SERVICE BULLETIN

N° **189-387**

ATA 21 - HEATING DUCT REAR AVIONIC BAY MODIFICATION

SERVICE BULLETIN "SB-70688-21-01" REV.0, DATE 26/01/2023

Figure 2

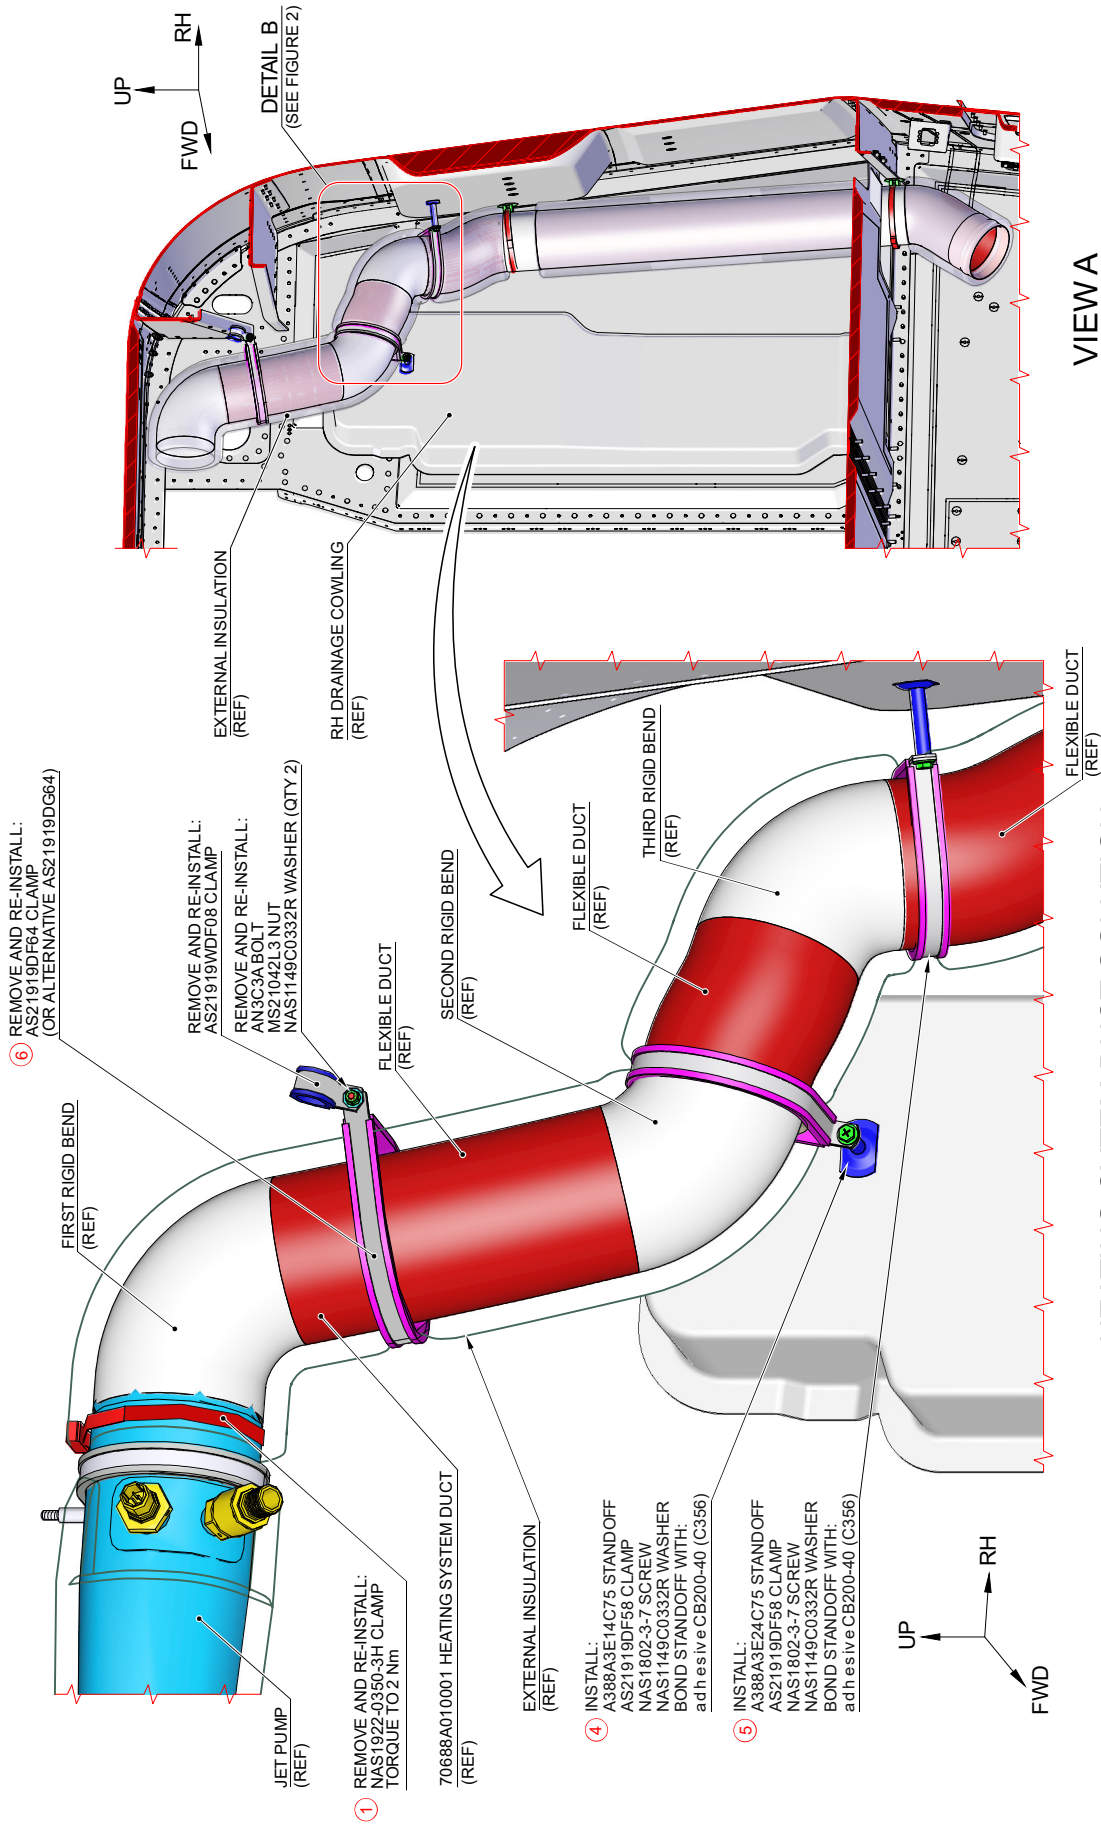
- 3.4 With reference to Figure 2 Detail B (WAS), remove the clamp P/N AS21919DF64, the nut P/N MS21042L3 and the washer P/N NAS1149C0332R from the heating system duct P/N 70688A010001 at position n°1. In accordance with AMP DM 89-A-20-10-16-02A-920A-A and with reference to Figure 2 Detail B (WAS), remove the existing stud P/N A366A3E10C from the panel at the same position.

- 3.5 With reference to Figure 2 Detail B (WAS), remove the tiedown strap P/N AW001CK06HS. Remove also the support P/N AW001CL002C-X1 from the structure.

- 1 REMOVE:
A366A3E10C STUD
AS21919DF64 CLAMP
MS21042L3 NUT
NAS1149C0332R WASHER

Figure 1

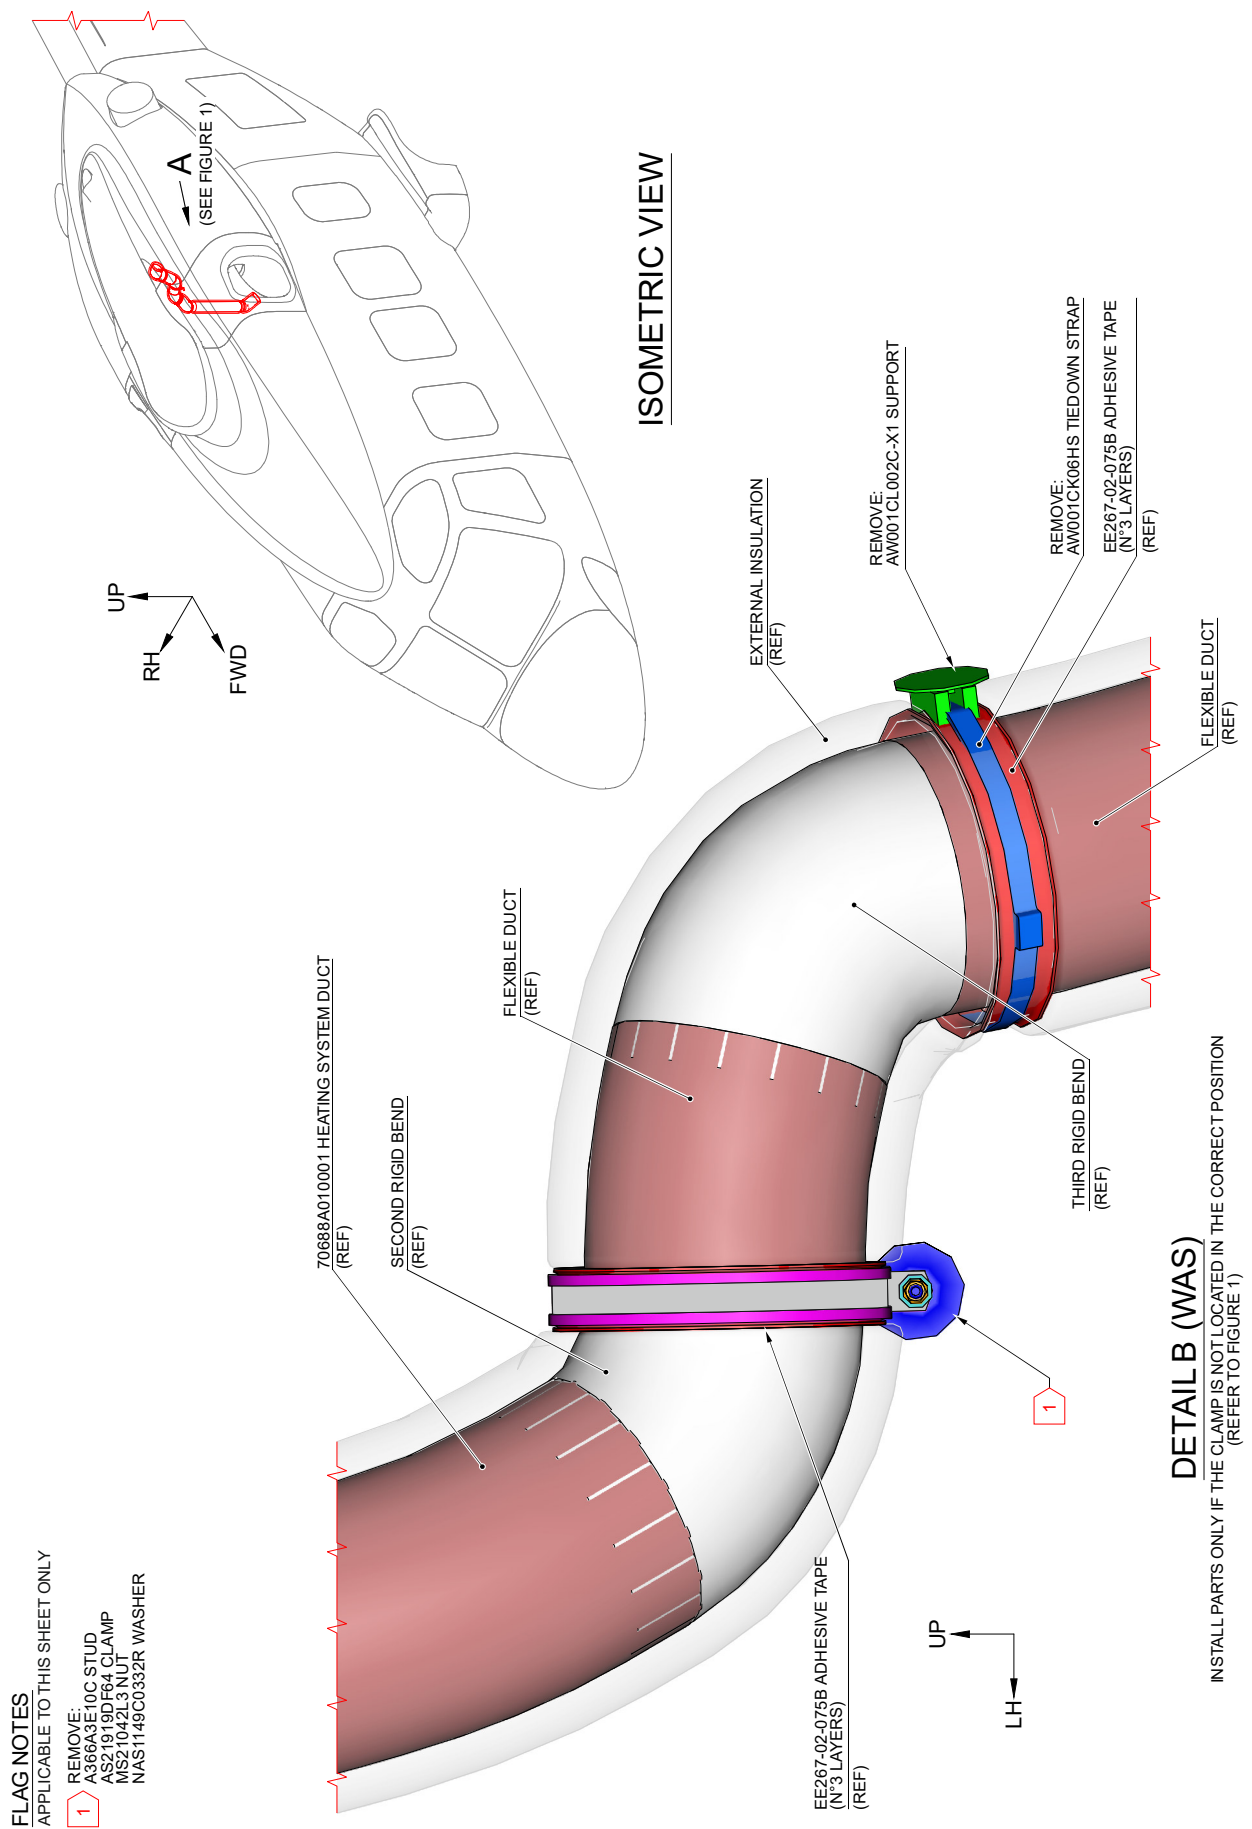
1. In accordance with AMP DM 89-A-00-20-00-00A-120A-A, prepare the helicopter on ground for a safe maintenance. Disconnect the battery, all electrical power sources and/or the external power supply.
2. In accordance with AMP DM 89-A-06-41-00-00A-010A-A and with reference to Figure 1 get access on the right side of the baggage compartment by removing all necessary panels, liners, fixing hardware and avionics equipment installed next to right-hand afterward heating system duct area.
3. With reference to Figures 1 thru 3, remove the heating system duct P/N 70688A010001 as described in the following procedure:
 - 3.1 In accordance with applicable steps of AMP DM 89-A-21-40-09-00A-520A-A and with reference to Figure 1, remove the clamp P/N NAS1922-0350-3H that connects the duct to the jet pump (location 1) and carefully move away the duct from the jet pump. Retain hardware for further use.

- 3.3 With reference to Figure 1, remove the bolt P/N AN3C3A, the nut P/N MS21042L3, n°2 washers P/N NAS1149C0332R and the clamp P/N AS21919WDF08 (location 6). Retain hardware for later use.

- 6.5 With reference to Figure 1, identify the location 4 on the second rigid bend (between the second rigid bend and the flexible duct) by gently compressing the duct by hand, then mark the position on the second rigid bend by means of three layers of adhesive tape P/N EE267-02-075B.
- 6.6 With reference to Figure 1, temporarily locate the clamp P/N AS21919DF58 on the taped area and countermark the location 4 of the standoff P/N A388A3E14C75 on the panel.
- 6.7 In accordance with AMP DM 89-A-20-10-16-02A-920A-A and with reference to Figure 1, install the new standoff P/N A388A3E14C75 on the panel at location 4 by means of adhesive CB200-40 (C356).

- 6.8 In accordance with AMP DM 89-A-20-00-00-00A-711A-A and with reference to Figure 1, install the clamp P/N AS21919DF58 on the heating system duct P/N 70688A010001-R at location 4 by means of the washer P/N NAS1149C0332R and the screw P/N NAS1802-3-7. Tighten the screw to the standard torque value.

- 6.9 With reference to Figure 1, identify the location 5 on the third rigid bend (between the third rigid bend and the flexible duct) by gently compressing the duct by hand and mark the position on the third rigid bend by using three layers of adhesive tape P/N EE267-02-075B.
- 6.10 With reference to Figure 1, temporarily locate the new clamp P/N AS21919DF58 on the taped area and countermark the location 5 of the standoff P/N A388A3E24C75 on the panel.
- 6.11 With reference to Figure 1, install the new standoff P/N A388A3E24C75 on the panel at location 5 by means of the adhesive CB200-40 (C356).

- 6.12 With reference to Figure 1, install the clamp P/N AS21919DF58 on the heating system duct at location 5 by means of the washer P/N NAS1149C0332R and the screw P/N NAS1802-3-7. Tighten the screw to the standard torque value.
- 6.13 With reference to Figure 1, install the clamp P/N AS21919DG64 and the clamp P/N AS21919WDF08 (location 6) by means of the bolt P/N AN3C3A, the nut P/N MS21042L3 and n°2 washers P/N NAS1149C0332R. Tighten the nut to the standard torque value.
7. In accordance with AMP DM 89-A-06-41-00-00A-010A-A and with reference to Figure 1 and 3, re-install all necessary panels, liners, fixing hardware and avionic equipment previously removed.
8. Remove all the tools and other items from the work area.

Figure 3

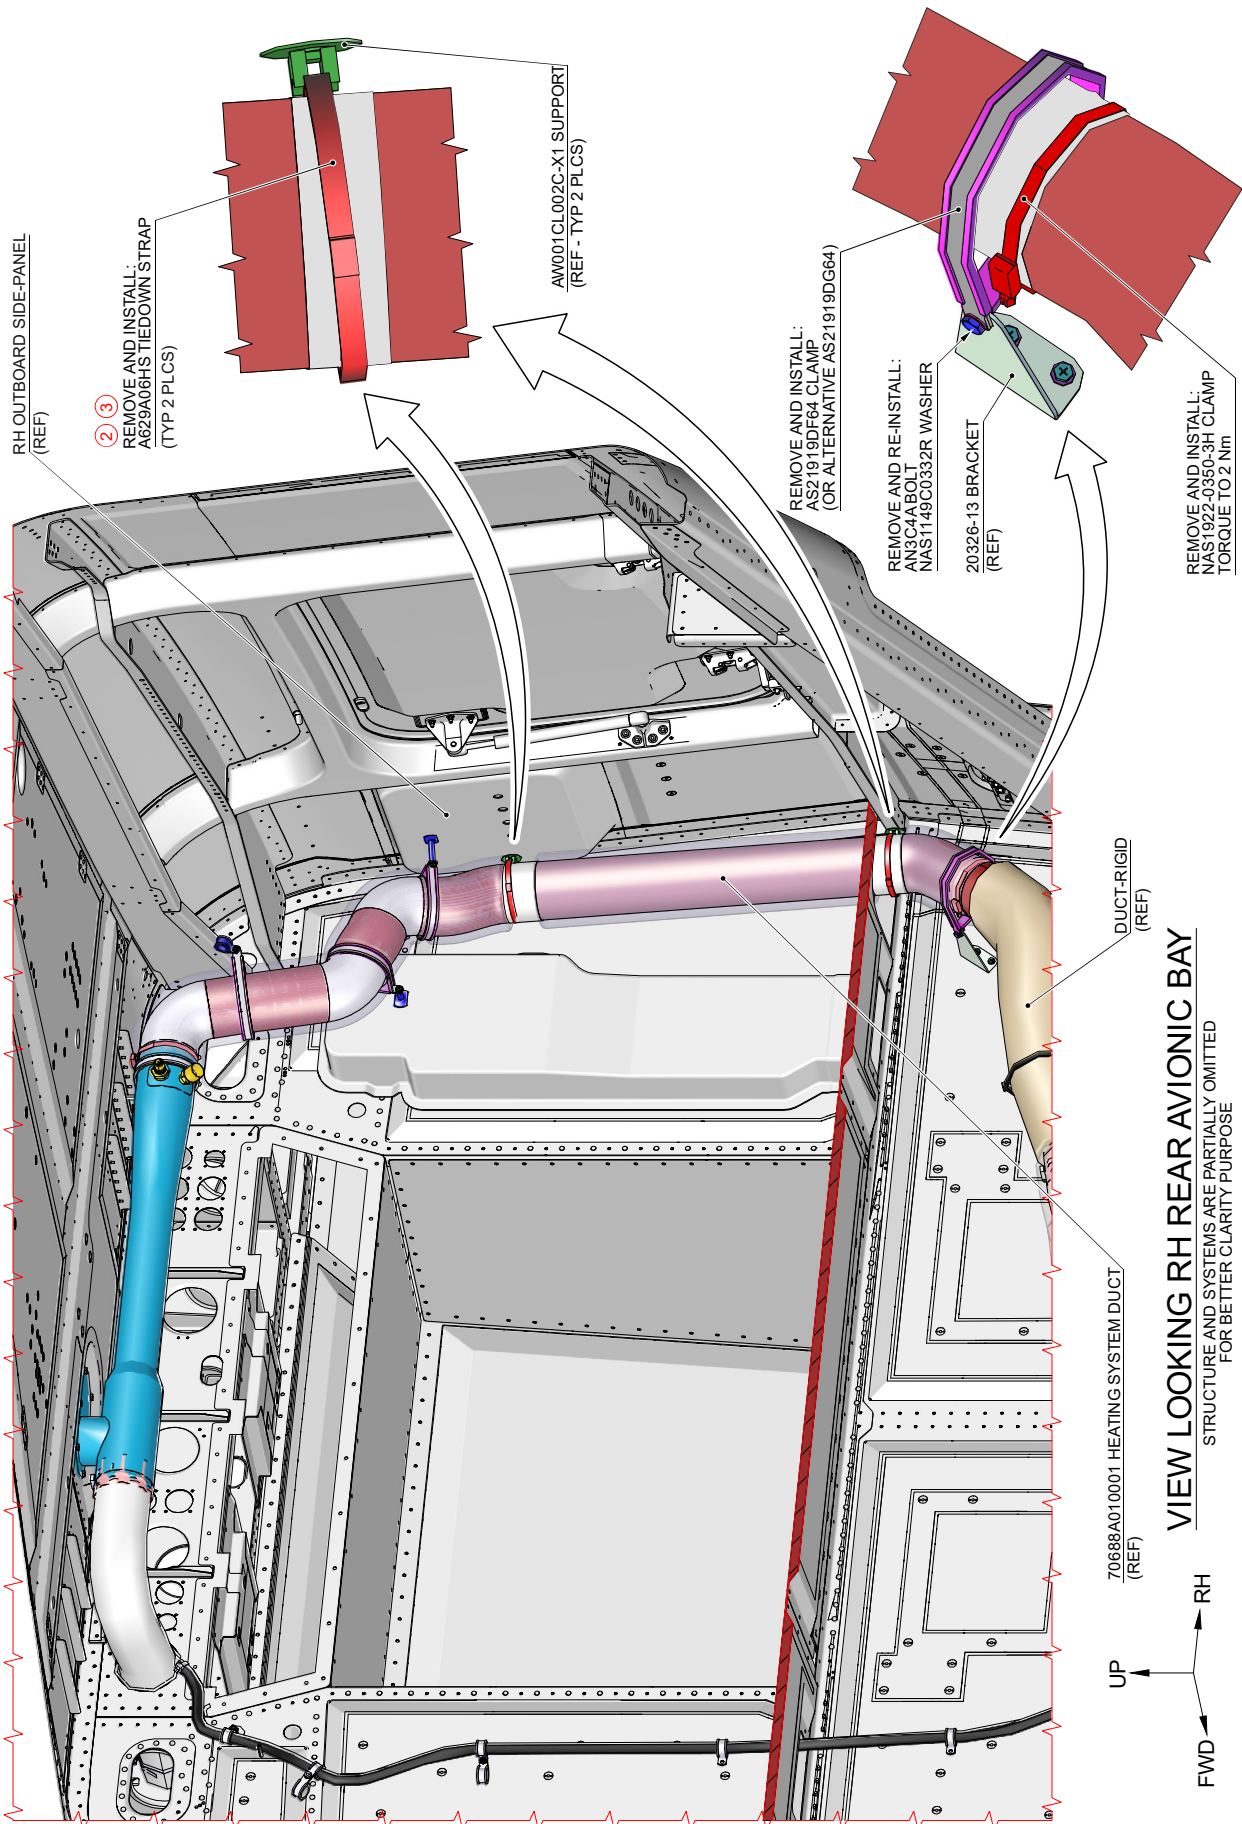
- 3.2 With reference to Figure 3, get access to the lower part of the duct and remove the bolt P/N AN3C4A, the nut P/N MS21042L3, the washer P/N NAS1149C0332R, the clamps P/N AS21919DG64 and P/N NAS1922-0350-3H. Retain hardware for later use.

- 3.6 With reference to Figure 3, remove the n°2 tiedown strap P/N A629A06HS that secure the duct to the outboard side-panel (locations 2 and 3).
4. In accordance with procedure reported in Service Bulletin “SB-70688-21-01” Section 2.G (refer to Annex A), perform the reinforcement procedure for the heating system duct.

- 6.3 With reference to Figure 3, install n°2 tiedown straps P/N A629A06HS on the heating system duct (locations 2 and 3).
 - 6.4 With reference to Figure 3, install the clamp P/N AS21919DG56 to the bracket P/N 20326-13 by means of the bolt P/N AN3C4A and the washer P/N NAS1149C0332R.

Figure 1 – Duct with the 5 joints to be reinforced.

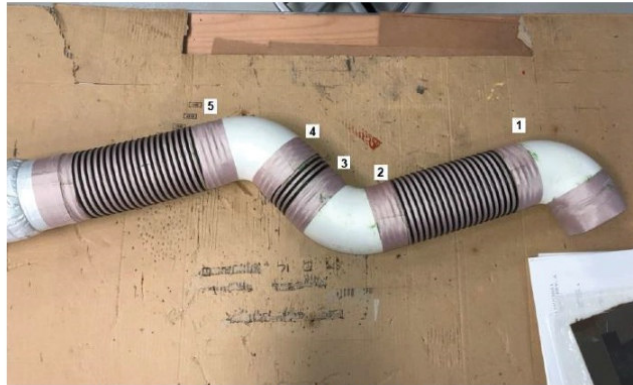
Step 1 - Carefully remove the insulation between the top clamping position of the long flexible length and the jet pump cuffed end, in one complete piece cutting along the length between these 2 points. Preserve for reuse if possible subject to in-service degradation. [See Figure 1.](#)

Figure 10

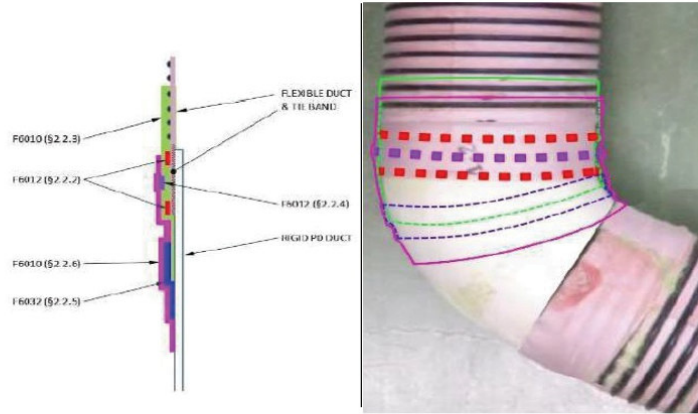
For better understanding, the schematic for the final overlap for each reinforced joint is shown in [Figure 10](#).

Figure 11

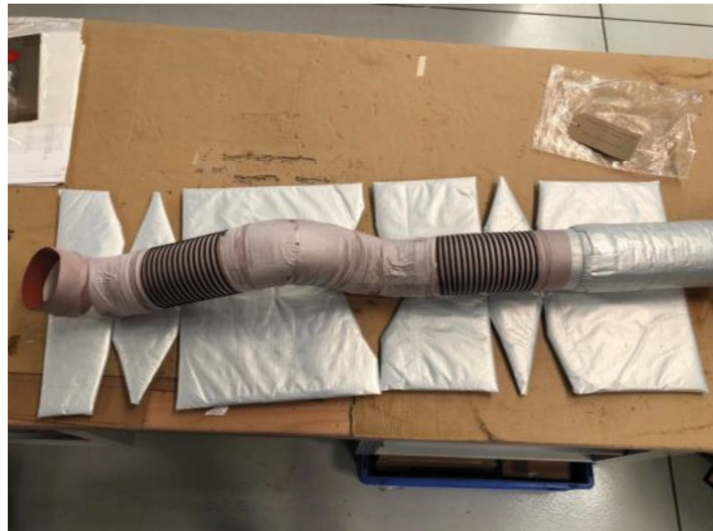
Step 9 - If the removed cover is damaged beyond use replace with a completely sealed 2-piece blanket (BWT40185-1 & BWT40185-3) and tape in place using 50mm wide F6291 RPFPT Metallised PVF Self Adhesive Tape as shown in [Figures 11 and 12](#).
